Title				BMS_LV			
Size	A3	Number		Revision	V2.1		
Date:	7/06/2024			Sheet of			
File:	Master_V2_1.SchDoc			Drawn By:

Title			
BMS_LV			
Size	Number	Revision	
A3		V2.1	
Date:	7/06/2024	Sheet of	
File:	Connectors_V2_1.SchDoc	Drawn By:

Connectors\_V2\_1[1B] < LV\_CMD\_GPIO\_OUT > LV\_CMD

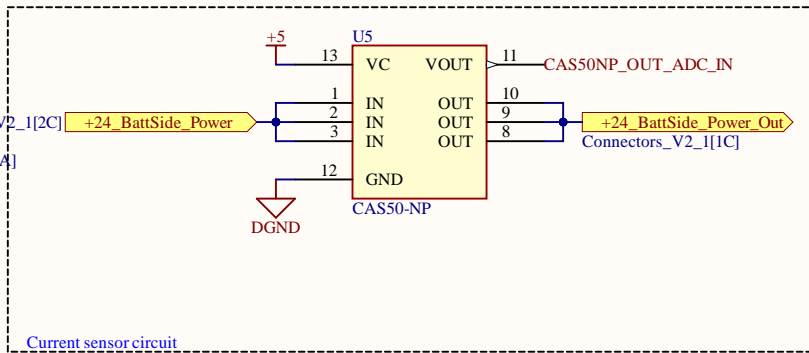
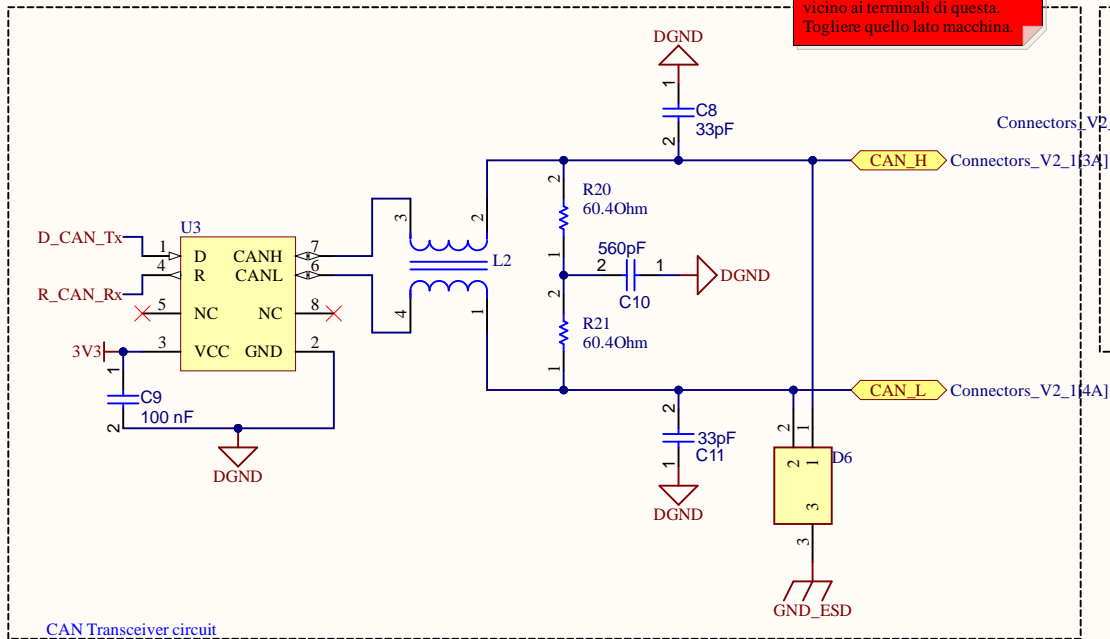
Mettere un fusibile lato batteria vicino ai terminali di questa. Togliere quello lato macchina.

Per la PCB:  
Il sensore di corrente è riferito a DGND ma la pista in uscita dovrà essere sopra una striscia di AGND.

Connectors

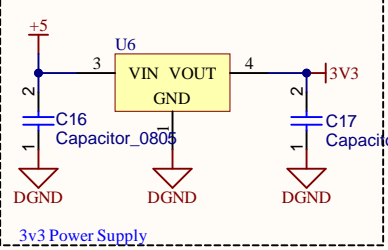
Per la PCB:  
-Sul lato sinistro della scheda vanno i connettori con i segnali di CAN (J9).  
-Sul lato destro i connettori con: i segnali di potenza, l'alimentazione e per il controllo del relay (J8, J10, J11 e J14).

Motivazione: per avere un cablaggio migliore (filì più corti).
